Planning Assessment Officer Report

PA2504015– 2-6 Lampard
Road, Drouin

Planning Assessment Officer Report
Development Assessment

Figure 7: Townhouse bin enclosure (Source: Application)

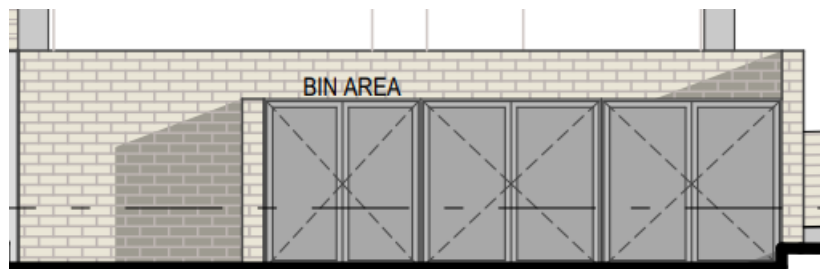
93. The proposed waste storage and management are generally acceptable. However, a condition of permit will require internal waste storage spaces to be shown, as required by Standard B5-5 (Waste and recycling) and as recommended by the Council.
